Type 531A/RM

PRODUCT MODIFICATION INDEX

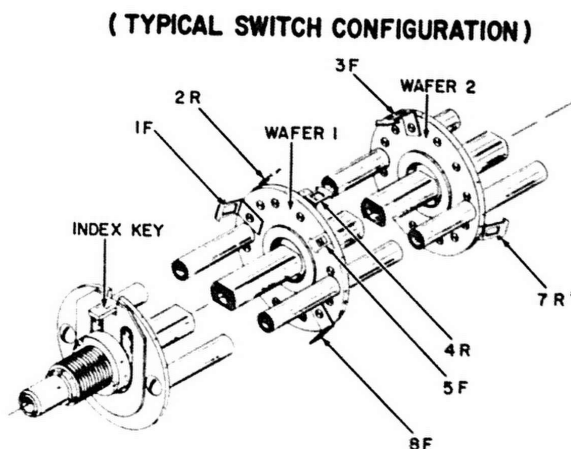
1. Remove the following:
 - () bare wire between W1-1F and the top of R593.
 - () RC combination (1 M - 4.7 pF) between W1-4F and W1-1F.
2. Solder the following (from kit):
 - () R1-C1, 1 M - 4.7 pF combination, between W1-4F and the top of R593.
 - () R5, 10 M, between W1-1F and the front detent plate.
 - () C2, 0.02 μ F, between W1-1F and the top of R593.

- 6. Remove the following:
 - () bare wire between W1-6R and W2-7R.
 - () white stranded wire from W1-7F.
 - () R51-C51 combination connected between W1-7F and W2-7R.
- 7. Solder the following (from kit):
 - () R55, 10M resistor, between W1-7F and the front detent plate.
 - () C52, an 0.01 μ F capacitor, between W2-7R and W1-7F.
 - () R51-C51 combination from W1-6R to W2-7R.
 - () white wire (removed in step 6) to W2-7R.

TIME BASE B TRIGGER
(Partial Diagram)

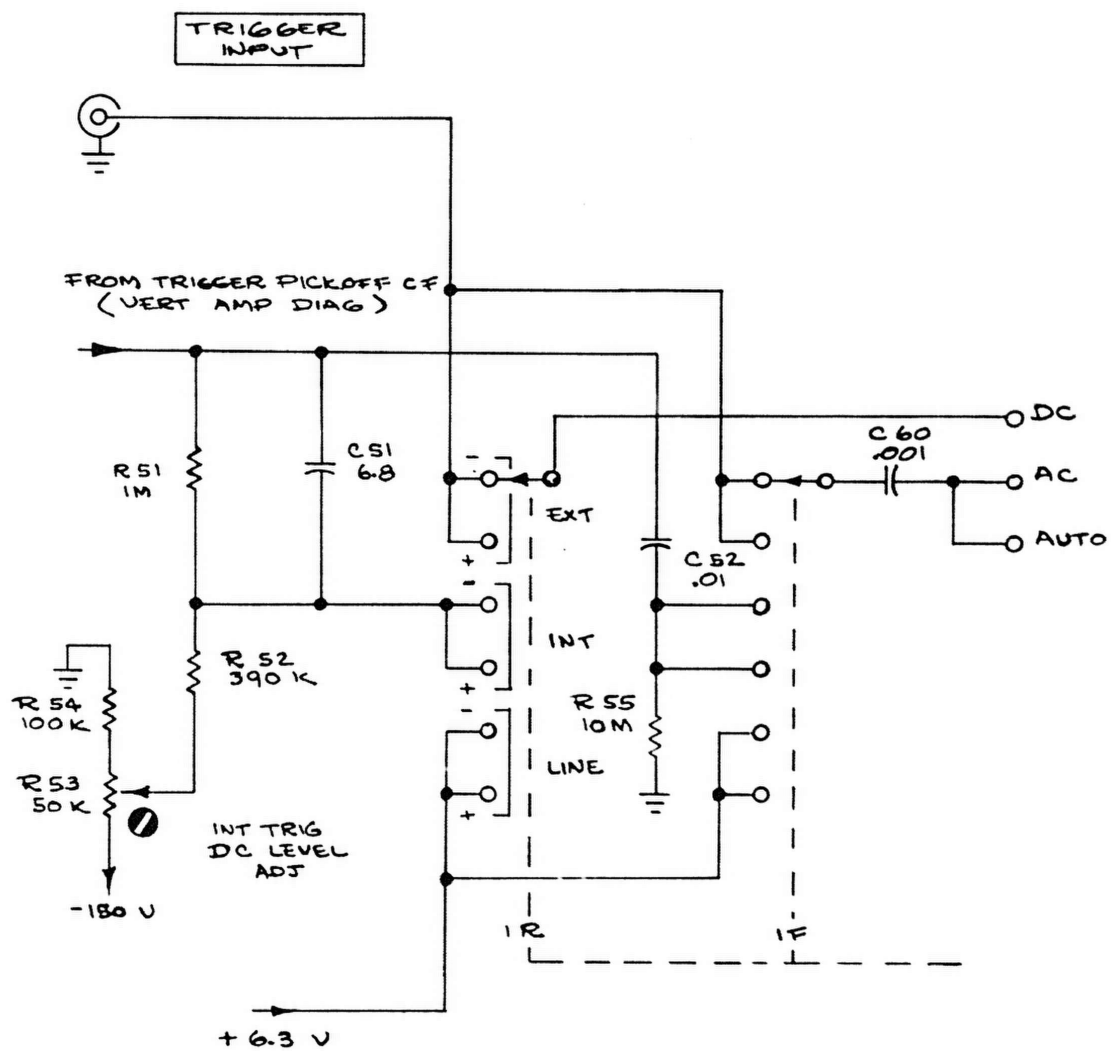
This modification eliminates the possibility of a large voltage spike appearing at the TRIGGER INPUT connector when switching from internal to external triggering positions.

A decoupling network is added to the INT position of the following Trigger Selector (TRIGGERING MODE, TRIGGER SLOPE) Switches (the wired switch part numbers are changed accordingly):

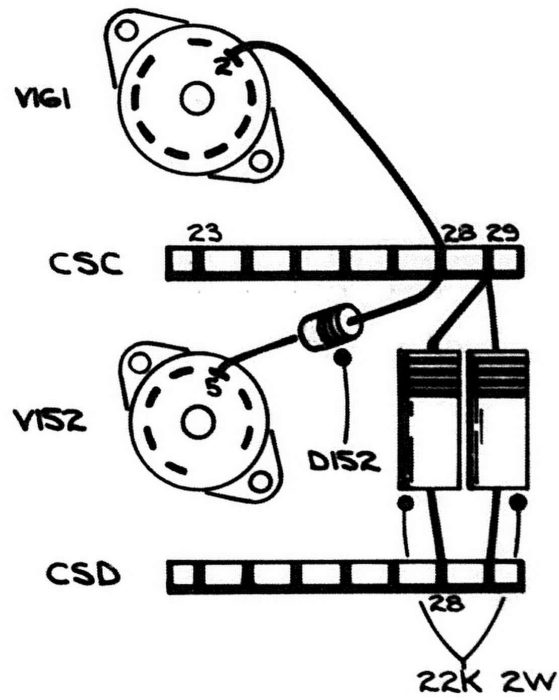
A low leakage semiconductor diode was added in series with the Miller tube control grid disconnect diode. This combines the low leakage characteristics of the semiconductor with the fast turn-off capability of the vacuum diode. Also, selected vacuum tube disconnect diode (introduced Mod 9134) were changed back to raw tubes.

- Remove the bare wire between CSC-28 and CSC-29 (see drawing).
- Remove the white-green wire between pin 2 of V161 and pin 5 of V152.
- Replace the 22k 2W resistor (R165), between CSC-28 and CSD-28, with a new resistor, reconnecting one end to CSC-29, as shown in drawing.
- Add a #22 bare wire between pin 2 of V161 and CSC-28.
- Add diode D152 between CSC-28 (banded end) and pin 5 of V152.

C396 ADDED TO ELIMINATE SWEEP DISTORTION

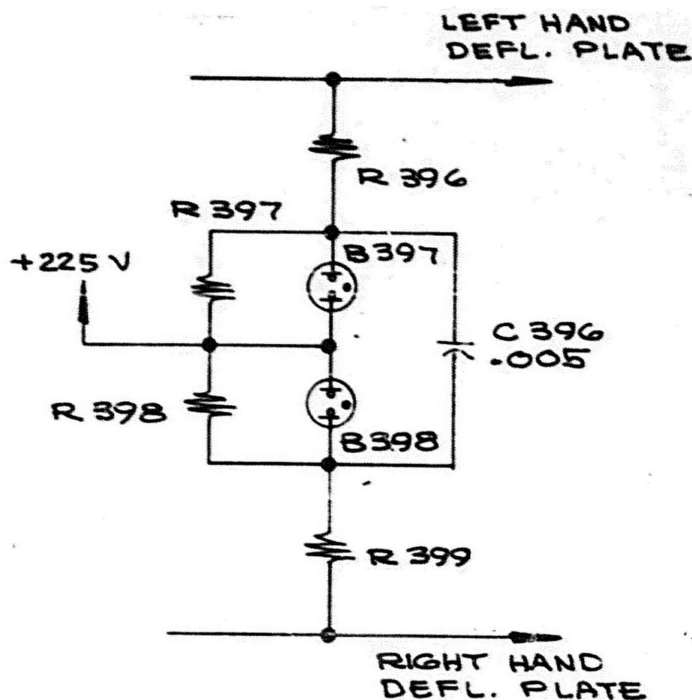
The left neon light fires too soon, distorting the sweep waveform. This is eliminated by adding a capacitor across the two horizontal neon indicators as shown in schematic.

On the ceramic strip just below the Norm/Mag Regis potentiometer (R358), add a 0.005 μ F discap between the junction of R398 (820k) and white-red wire and the junction of R397 (820k) and white-green wire.

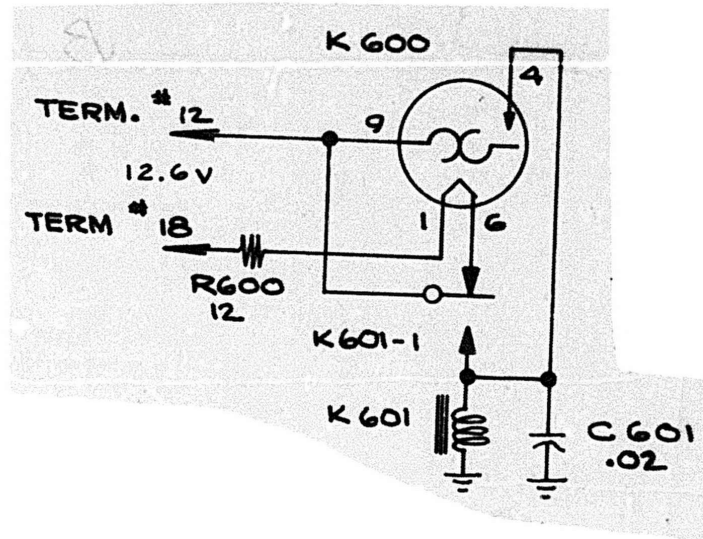
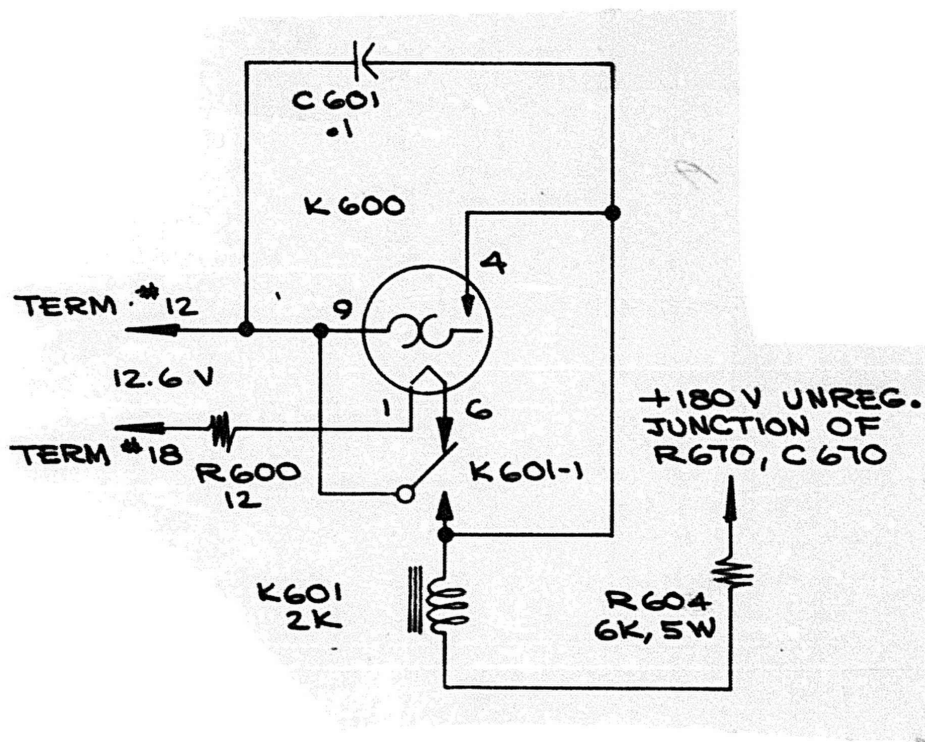
To eliminate AC pickup on the CRT display caused by magnetic flux leakage from the AC relay, reduce contact burning and relay noise, and lower the incoming inspection reject rate, the AC relay is changed to a DC type. The new relay operates off the +180V unregulated supply. See drawing.

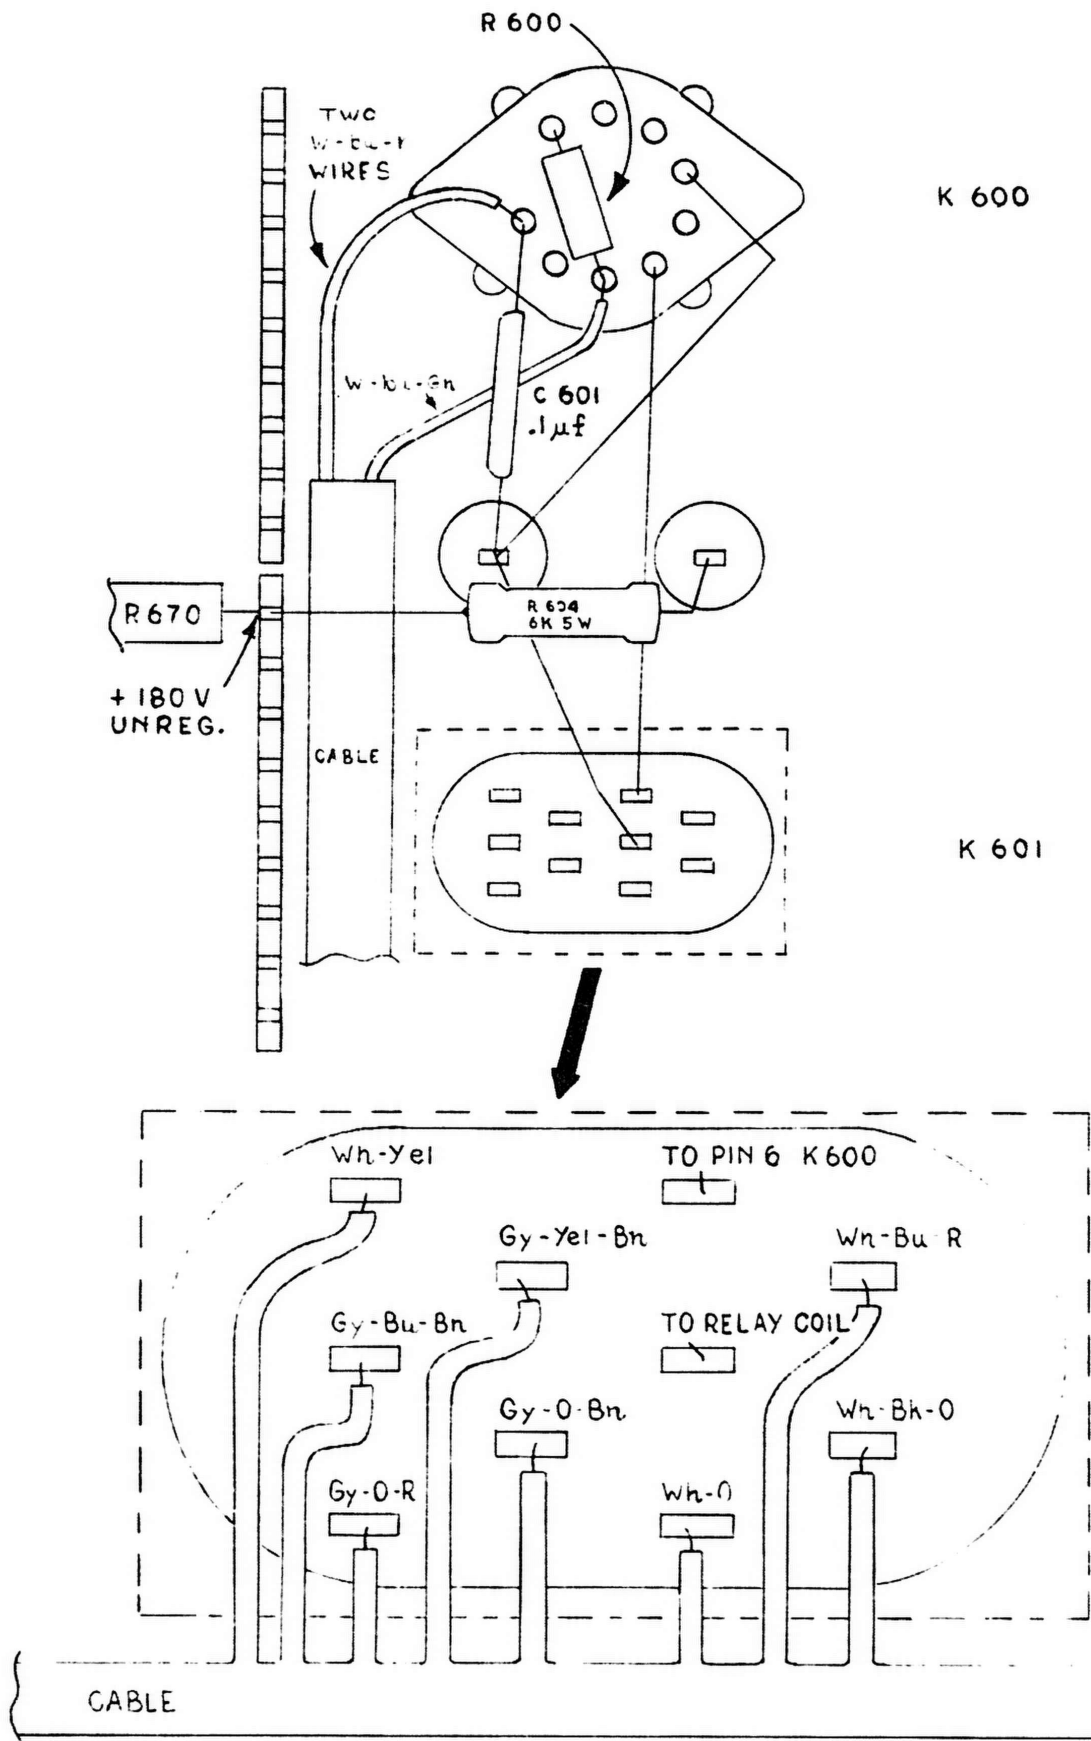
Modification Kit, PN 040-0258-00, changes the AC relay (K601) to a DC relay in the above listed instruments,* thus eliminating the 60Hz AC pickup on the CRT display.

- () 4. Replace the relay shield, removed in step 1a.
- () 5. Solder the wires to the relay contact terminals, as shown in drawing on page 2.
- () 6. Remove C601 (0.02 μ F capacitor connected from pin-4 of K600 to ground) and solder in the new C601 (0.1 μ F capacitor, from kit), from pin-4 (or at relay coil terminal, as shown in drawing) to pin-9 of K600.

- () 7. Install R604, 6k 5W WW resistor (from kit) as shown in drawing on page 3.
- () 8. Replace the Time Delay Relay (K600) in your instrument with the one from the kit.

DECOUPLING ADDED TO IMPROVE HF SYNC

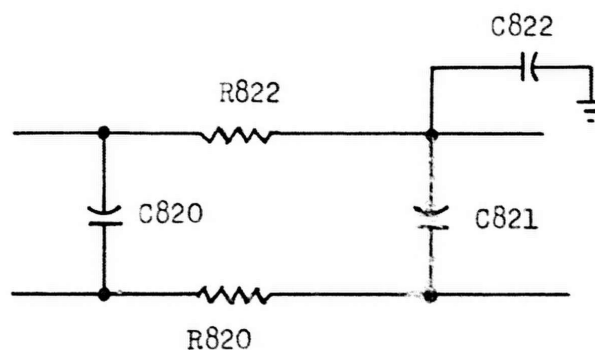
- Replace the bare wire that connects the two center slots of two ceramic strips (under the hv shield next to the transformer) with R822, 33k.
- Add C822, 470pF, between the R822/white-violet wire junction and the ground side of C803 (0.001 μ F capacitor adjacent to R822 and nearest the outside edge of the chassis).

H.V.
TRANSFORMER
BOARD

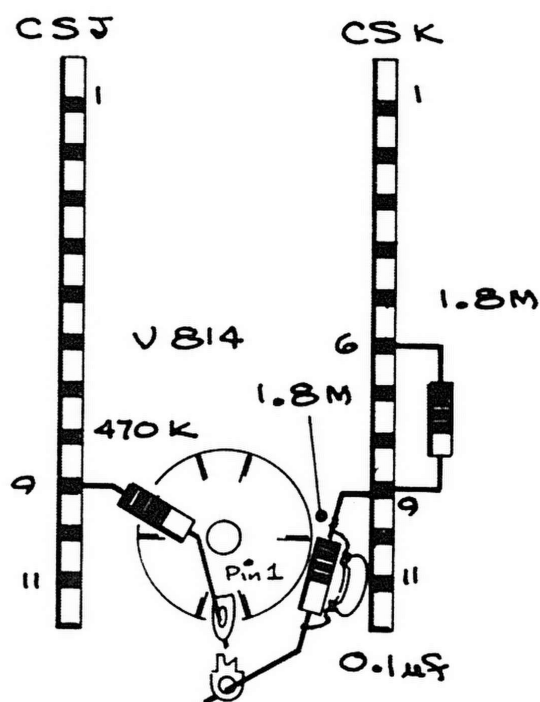
Several components are added to the HV circuit to eliminate the unblanking dim-out at the start of the sweep (at 10ms/cm) caused by HV transformer capacitance.

- a) Remove both HV shields.
- b) Remove strap between CSK-9 and V814 pin 1.
- c) Move end of R814, 470k 1/2W, connected to CSK-9, to V814 pin 1.
- d) Add R818, 1.8 meg, between CSK-6 and CSK-9.
- e) Add R819, 1.8 meg, and C819, 0.1 μ F, in parallel, between CSK-9 and V814 ground lug.
- f) Move the white wire, connected to CSB-11, to CSB-9.
- g) Move R827, 33k, connected between CSB-8 and 11, to between CSB-7 and 9.
- h) Add R829, 22k, and C829, 0.001 μ F, in parallel, between CSB-9 and CSB-11.

CRT CIRCUIT FILTERING ADDED

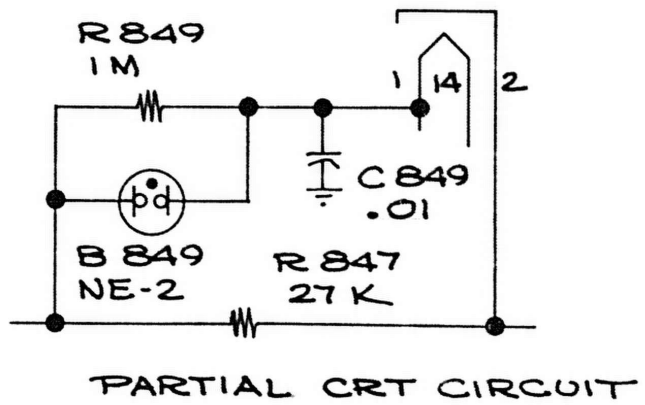
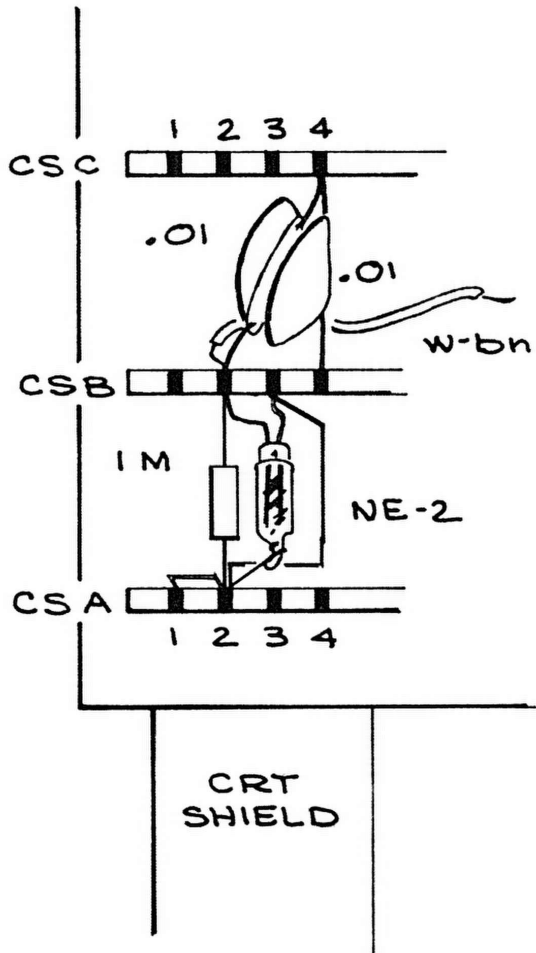
A filter is added to the CRT filament circuit to reduce 400 cycle intensity modulation. Also see Mod 7843, which replaces NE2 neons with NE23's.

- On the chassis above the base of CRT, move strap from CSA-1 to CSA-2.
- Add strap between CSA-1 and CSA-2.
- Move the white-brown wire from CSB-3 to CSB-2.
- Install C849, 0.01 μ F capacitor between CSB-2 and CSC-4.
- Install R849, 1 meg 1/2W 10% between CSA-2 and CSB-2.
- Install B849, NE-2 between CSB-2 and CSB-3.
- Install the neon bulb holder in CSA-2.

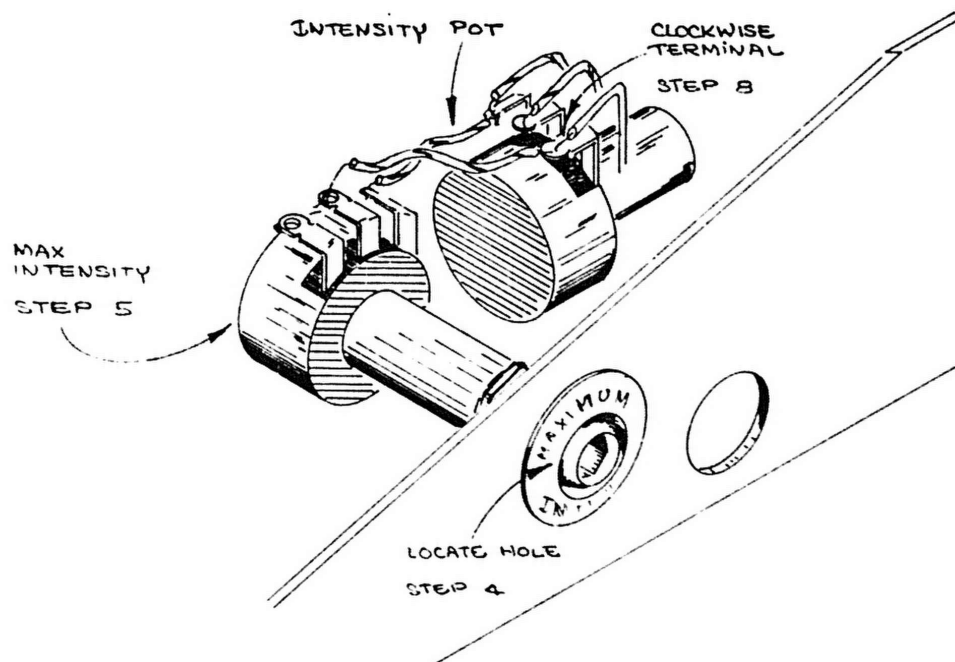
The object of this modification is to prevent cathode-ray tube phosphor from burning, especially at slow sweep speeds. Basically the modification consists of replacing the 1M INTENSITY potentiometer with two 2M potentiometers in parallel. One is a screwdriver adjustment, the other is the front panel INTENSITY control.

- () Replace the knob.
- () 4. Locate the plate on top of the plug-in housing. On the outside flange, mark and drill a 3/8 in. hole, 3/4 in. from the bottom, and 3 in. from the front panel (see drawing).

- () 5. Install the 2M potentiometer (from kit) that has the two wires soldered to it. Use the large lockwasher on the inside of the flange, install the bushing from the outside over the MAX INT tag and tighten with a 1/4 in. allen wrench (see drawing, step 5).

- () 6. Solder the white-green wire to the center terminal of the INTENSITY potentiometer.
- () 7. Solder both the white-brown wires (one that was removed from the old INTENSITY potentiometer, and one that is connected to the MAX INT potentiometer installed in step 5) to the counter-clockwise terminal of the new INTENSITY potentiometer (see drawing).

- () 8. Solder both white-orange wires (one that was removed from the old INTENSITY potentiometer, and one that is connected to the MAX INT potentiometer installed in step 5) to the clockwise terminal of the new INTENSITY potentiometer (see drawing, step 8).

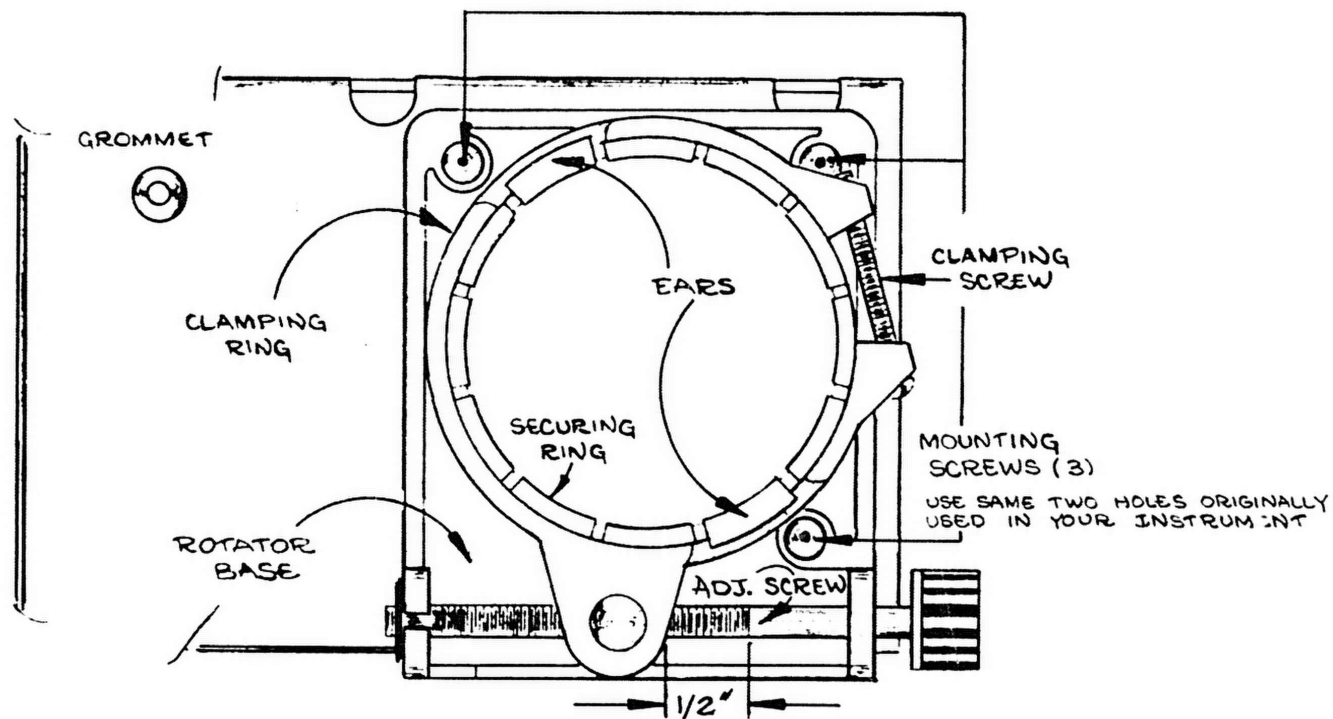
REFER TO DRAWING OF CRT ROTATOR ASSEMBLY ON FOLLOWING PAGE.

- () 3. Remove clamping ring and adjusting screw from the old assembly and install on new CRT rotator base from the kit.

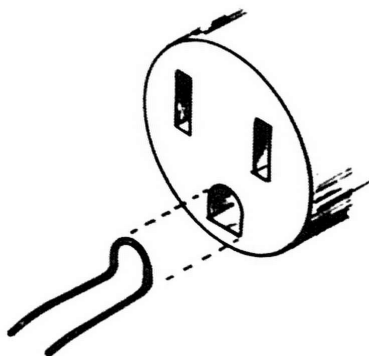
- () Insert the spring (from kit) as indicated in the drawing below, and push it in by plugging the male end of the power cord into the female end.

FIG. 2

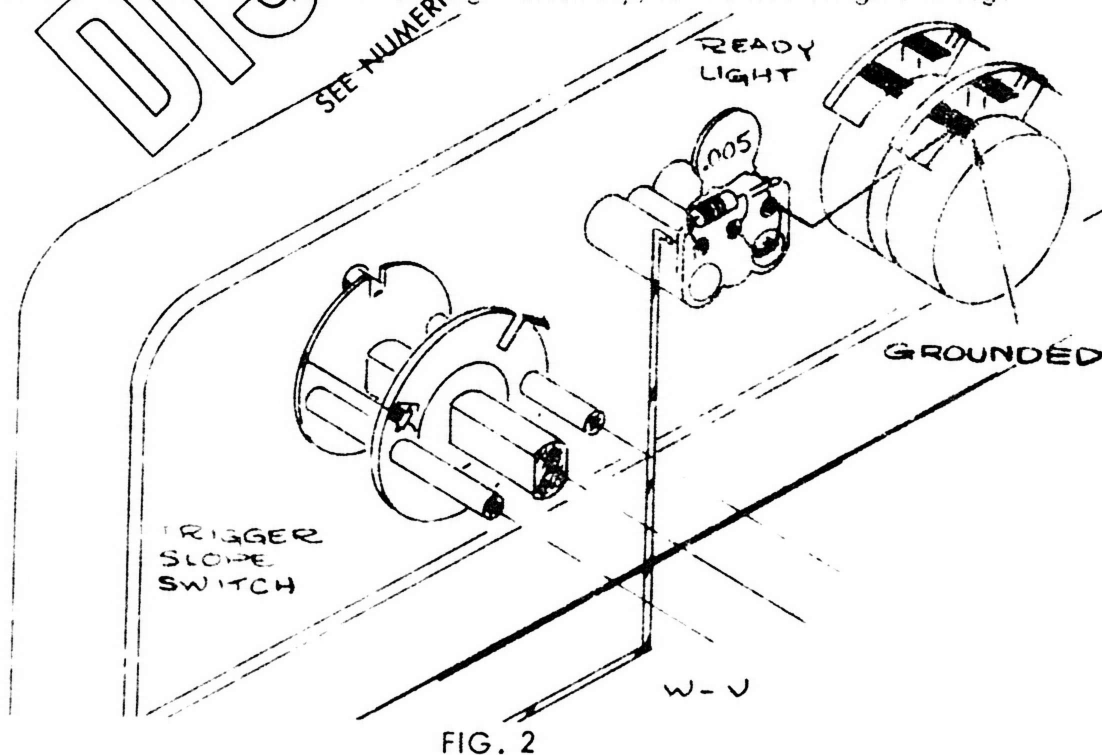
- () 1. Dress the larger cable from the circuit board assembly through the grommet installed in step B-6.
- () 2. Solder the white-violet wire from the cable to the junction of the 10k resistor and 0.005 μ F capacitor on the READY tag assembly. See Fig. 2.
- () 3. Solder the bare wire (on READY tag assembly) to the nearest ground lug.
